**TAHERA RESPONSE TO INAC CONCERNS;  
INAC REVIEW OF TYPE A WATER LICENSE ANNUAL  
REPORT AND AUGUST 2008 INAC SITE INSPECTION**

*Tahera Diamond Corporation*

December 8, 2008

Tahera has reviewed concerns by the department of Indian and Northern Affairs Canada (“INAC”) presented in a letter from Kevin Buck on October 21, 2008.

**Figure 1: Map of Project Area locating Lynne, Key and Ash Lakes, Waste Dump, Pit, Coarse PK and the Ammonium Nitrate Pad**

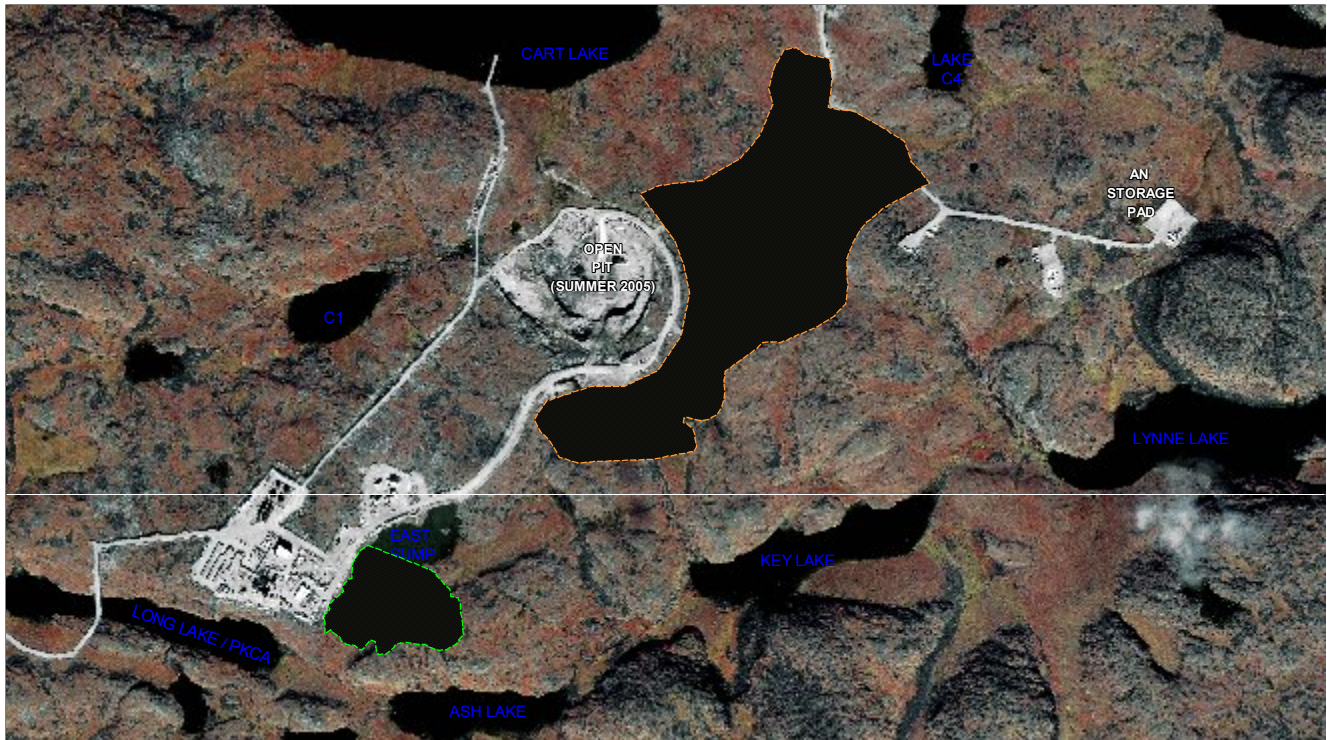
*A request to investigate the cause of elevated Ammonia and Nitrate in Lynne Lake (located below and downstream of the Ammonium Nitrate Storage Pad). (Annual Report Review)*

*Samples were taken from Carat Lake, Lynne Lake and Pond C-3. Preliminary results indicate that Nitrate and Ammonia levels in Lynne Lake were not above CCME Guidelines for the Protection of Aquatic Life. However, Tahera should continue to monitor possible impacts from runoff originating from the Ammonium Nitrate Storage Pad. INAC's sample results will be forwarded to Tahera with the Final Inspection report. (Inspection 2008)*

The ammonium nitrate ("AN") storage pad lies near the edge of the water shed of the Lynne / Key / Ash Lake system. Standing water around the AN pad may at times, depending on snow buildup and localized frozen ground, flow toward the Lynne Lake

system instead of the intended drainage into a local pond slightly northeast of the pad. (see figure 1) The AN pad was intended to be a lined / bermed storage pad, but Tahera had been allowed to operate without a lined pad until such time as one could be built. Currently the storage pad is not lined.

The concern for the Lynn Lake watershed would be an elevation of ammonia within Lynne Lake. The project was designed and permitted in such a way that the project is should have a negligible effect of the water quality of that watershed. From the analysis gathered to date, Tahera believes that the project has met its obligations in this respect.
